Modification Recommended Service Note

N8937A - Autoranging System DC Power Supply, 1500V, 30A, 15000W, 208 VAC

Serial Numbers: DE14290000 - DE15369999 without manufacturing ID Version "B"

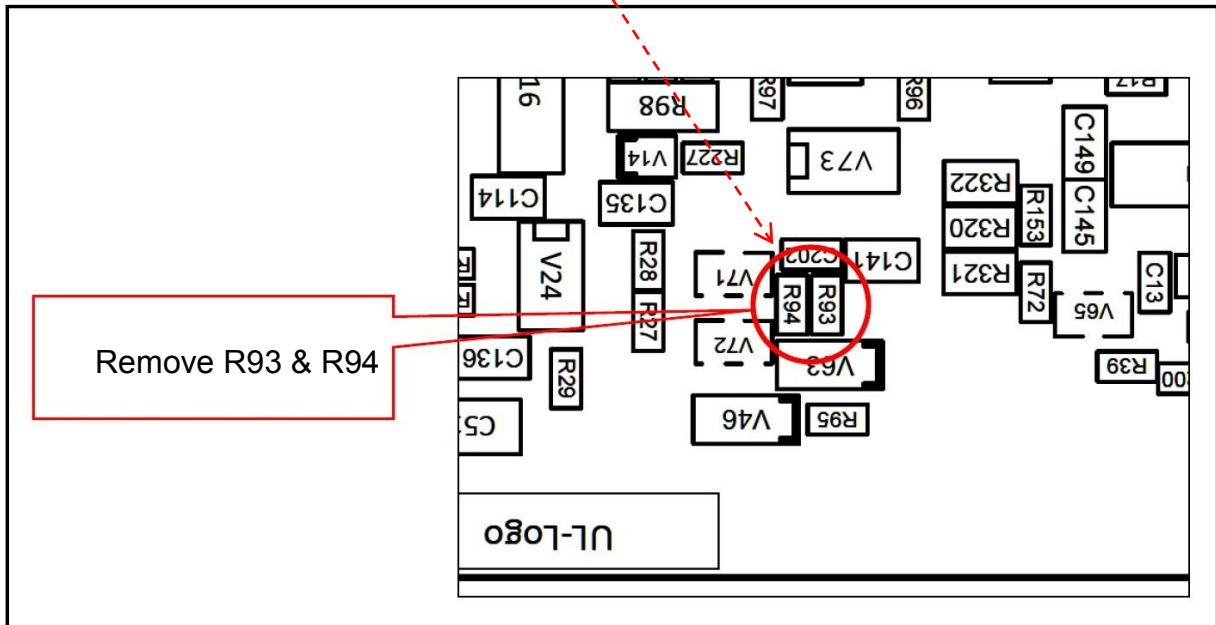
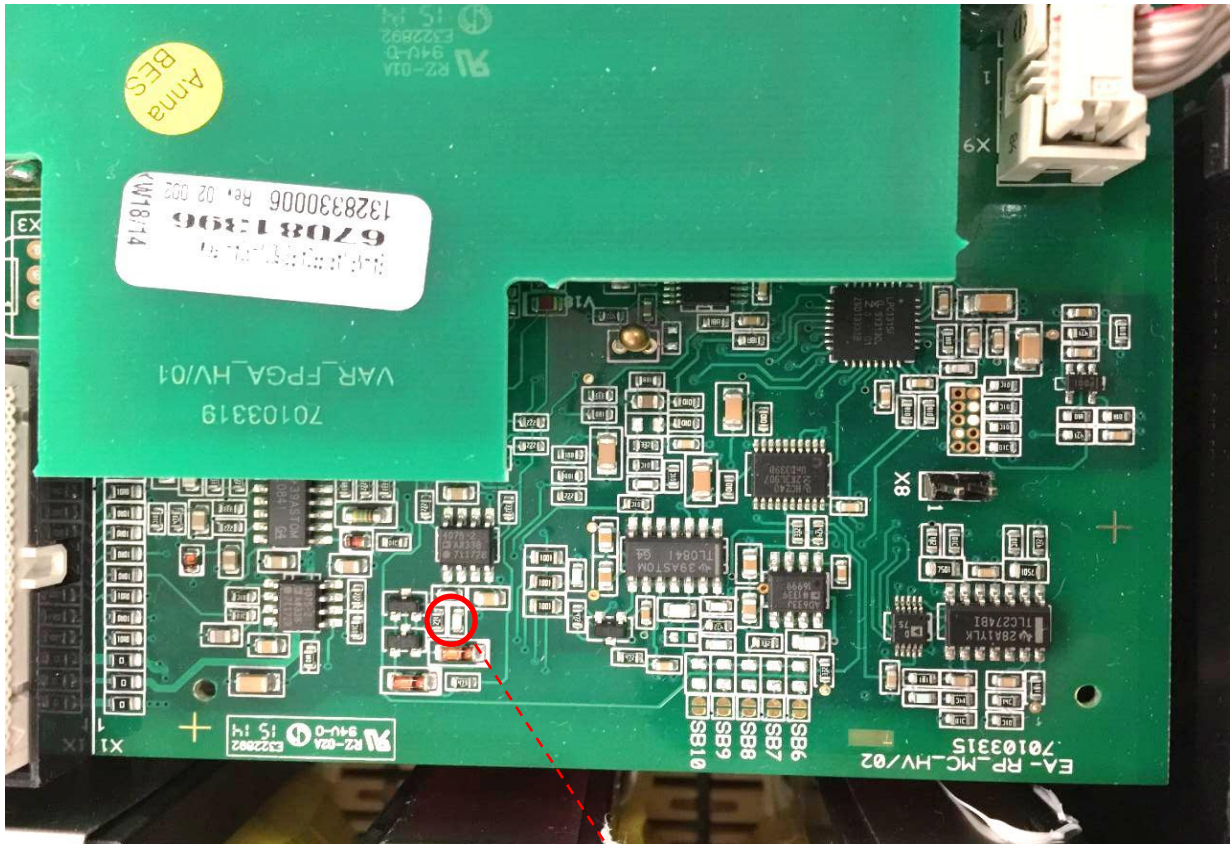
- 1) Remove acMains cable from power source.
- 2) Wait 5 minutes
- 3) Remove top cover from instrument.
- 4) In the 5kW units (viewed from the front of the unit), a small SMT assembly located at the right-rear of instrument will be readily visible (see below):

In the 10kW & 15kW units; although found in the same location, a black plastic cover will have to be removed to gain visibility and access to the SMT assembly. Plastic cover snaps-on and can be removed with a small screwdriver.

5) SMT resistors R93/94 are located in red circle shown below:

Resistors R93 and R94 must be removed, no replacement parts are required for modification.

Removal of two (2) surface mount resistors, R93 and R94, will correct this problem:

Suffix “B” added

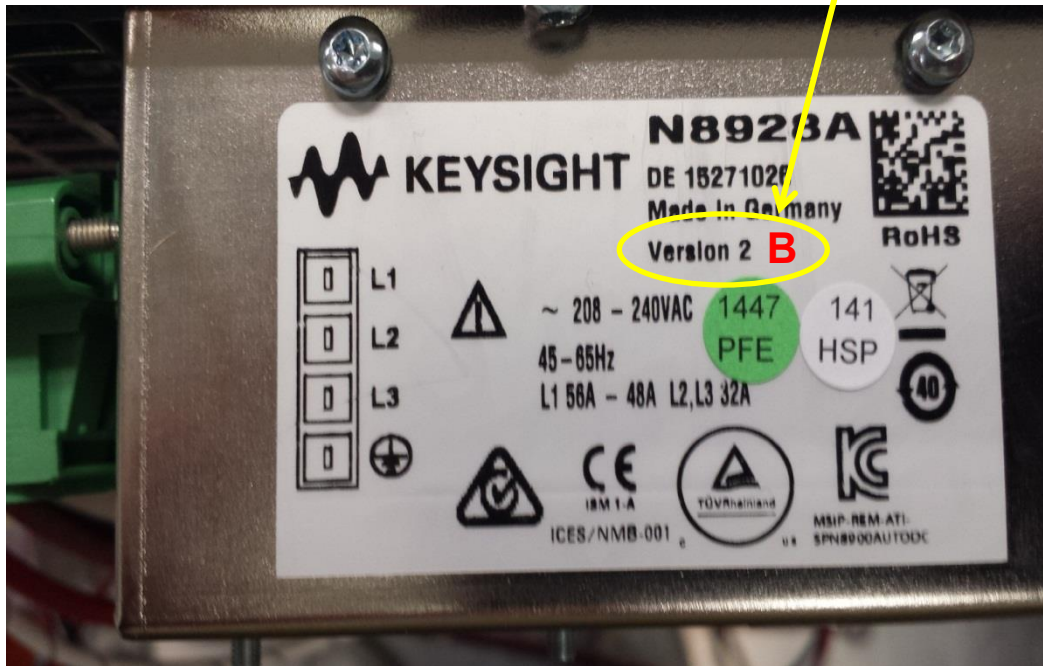
7) On the acMains label, on the rear of the instrument; use an indelible marker, to add the suffix letter “B” after the Version ID. This will assist in the tracking of modified instruments.
